Amendment C231 to the Yarra Planning Scheme
Comparison of *exhibited version* and the *version for adoption* and reasons for the change

Design and Development Overlay 16 (DDO16)

Attachment 3

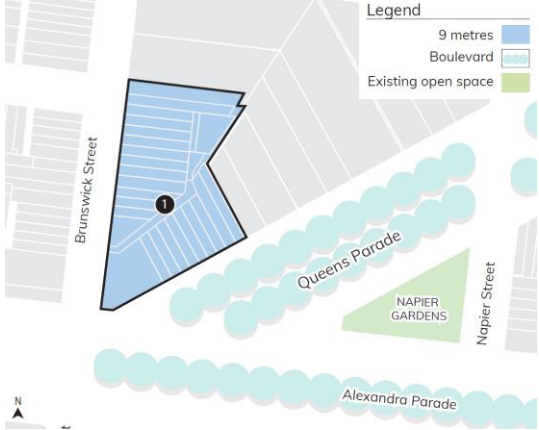
Clause & DDO element	Exhibited DDO	Version of DDO for Adoption	Reason for change
<p>2.9 Interface to residential properties in NRZ or GRZ</p>	<p>Heading not included in the <i>exhibition version</i>.</p>	<p>New sub-clause and heading added.</p> <p>The following new requirements are included:</p> <ul style="list-style-type: none"> • <i>Development should respond to the low scale form of existing development through an appropriate transition in building height and setbacks to ensure reasonable standards of amenity.</i> • <i>In Precincts 3 and 4, where sunlight to the secluded private open space of an existing dwelling is reduced, at least 75 per cent, or 40 square metres with minimum dimension of 3 metres, whichever is the lesser area, of the secluded private open space should receive a minimum of five hours of sunlight between 9 am and 3 pm on 22 September.</i> <p><i>If existing sunlight to the secluded private open space of an existing dwelling is less than the requirements of this standard, the amount of sunlight should not be further reduced.</i></p>	<p>In addition to changes to the side and rear setbacks, specific overshadowing controls were proposed in Precincts 3 and 4 in response to submissions.</p> <p>Submitters were concerned about the impacts of 4, 5 and 6 storey developments on the amenity of their properties to the south of the centre.</p> <p>Both requirements were relocated from Precincts 3 and 4 at the suggestion of the Panel – to reduce repetition.</p> <p>Requirement 1 which requires an ‘<i>appropriate transition to low adjoining low scale residential development</i>’ was supported by the Panel to address the interface with neighbouring residential properties.</p> <p>The purpose of the Requirement 2 is to protect adjoining residential properties from additional overshadowing at the equinox (the accepted urban design standard to apply when assessing overshadowing). The overshadowing requirements mirror ResCode Standards A14 and B21.</p>

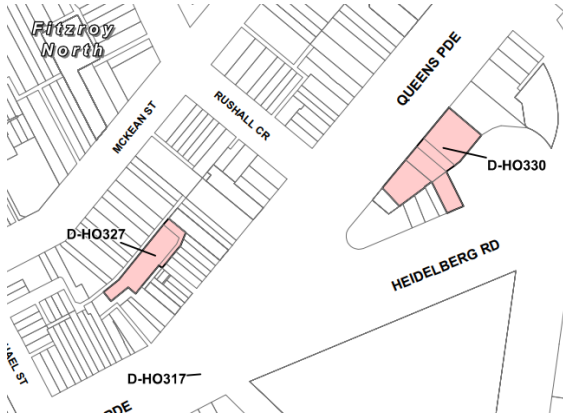
Property	Exhibited	Version for adoption	Reason for change
137 Queens Parade	The entry in Appendix 8 read: 	Entry updated to delete 'vacant' and replace with 'Apartments'.	It is proposed to change the description of the land at 137 Queens Parade in Appendix 8. When exhibited, Appendix 8 showed land at 137 Queens Parade as vacant. Since that time, apartments have been constructed on the land. Appendix 8 has been updated to reflect that change.
Raines Reserve	The entry in Appendix 8 read: 	Spelling of Raines Reserve corrected.	The third recommendation from the Panel was to correct the spelling of Raines Reserve (from 'Rains' to 'Raines'). Officers have corrected the spelling of it in Appendix 8.

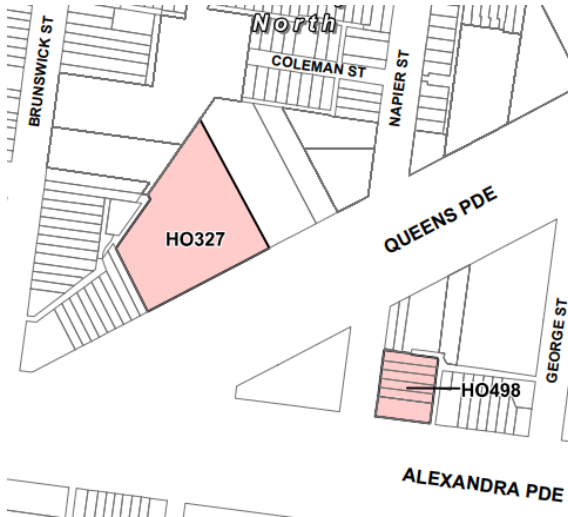
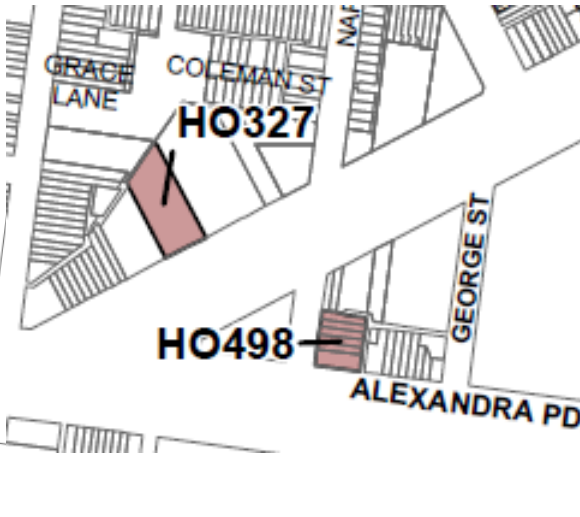
Exhibited	Version for adoption	Reason for change
Reference to the Statement of Significance was not included in the Schedule to the Incorporated Document. The Statements of Significance, exhibited as part of the GJM Built Form Heritage Analysis, were exhibited as 'reference documents'.	Reference added to the Statements of Significance: <i>Yarra High Streets: Statements of Significance</i> March 2020.	As outlined above, the exhibited Amendment sought to add <i>Yarra High Streets: Statements of Significance</i> by GJM Heritage, October 2017 (updated November 2017) (Appendix H) as a new reference document to Clause 22.02. However changes to Clause 43.01-5 (via Amendment VC148) now means that the document should become an incorporated document.

Planning Scheme Maps

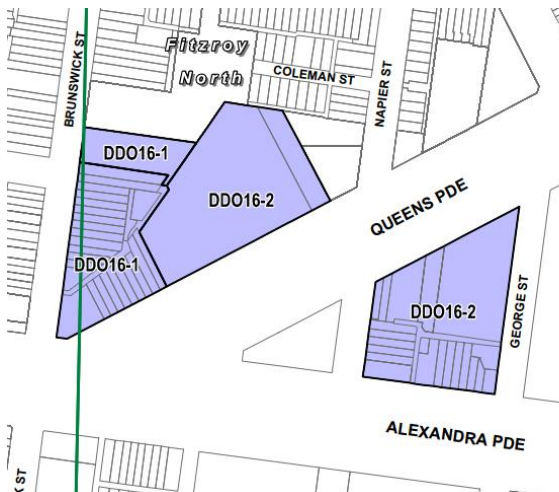
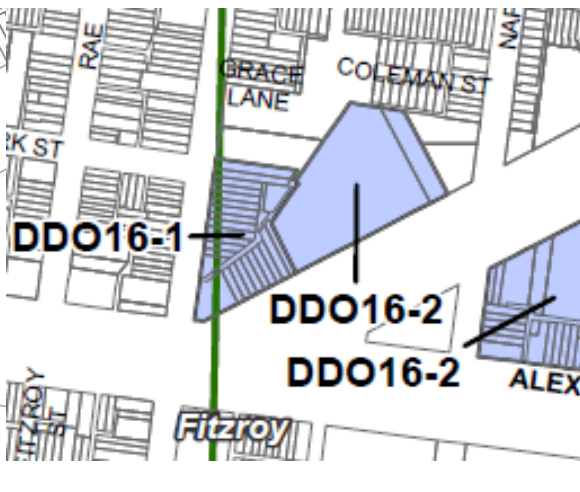
Property	Exhibited	Version for adoption	Reason for change
Heritage Overlay Maps			
<p>Clifton Motors (205-211 Queens Parade), 201-203 and 213-215 Queens Parade and 10-12 Dummett Crescent</p>	<p>Deletions:</p>  <p>Additions / changes:</p> 	<p>Deletions:</p>  <p>Additions / changes:</p> 	<p>Since exhibition of Amendment C231, the Minister for Planning has approved Amendment C267 to the Yarra Planning Scheme which was prepared by Heritage Victoria (to reflect the place's inclusion on the Victorian Heritage Register – VHR).</p> <p>Amendment C267 removed the Former Clifton Motor Garage from HO330 and included it in its own Heritage Overlay HO480.</p> <p>The exhibited version of C231 had proposed to include the Former Clifton Motors in its own Heritage Overlay but that is no longer required and accordingly will not now form part of the Amendment.</p> <p>The other issue arising in relation to the Former Clifton Motor Garage is that Heritage Victoria only included the land at 205-211 Queens Parade in HO480.</p> <p>The land at 10-12 Dummett Crescent, 201-203 and 213-215 Queens Parade is in the same ownership but was not included in HO480.</p> <p>The exhibited Amendment proposed to delete land at 10-12 Dummett Crescent from HO330 and give it its own Heritage Overlay. However, this change will not be progressed as it is no longer necessary.</p> <p>The site will therefore remain in HO330 along with the land at 201-203 and 213-215 Queens Parade. The Heritage Overlay map has been amended to reflect this change.</p>
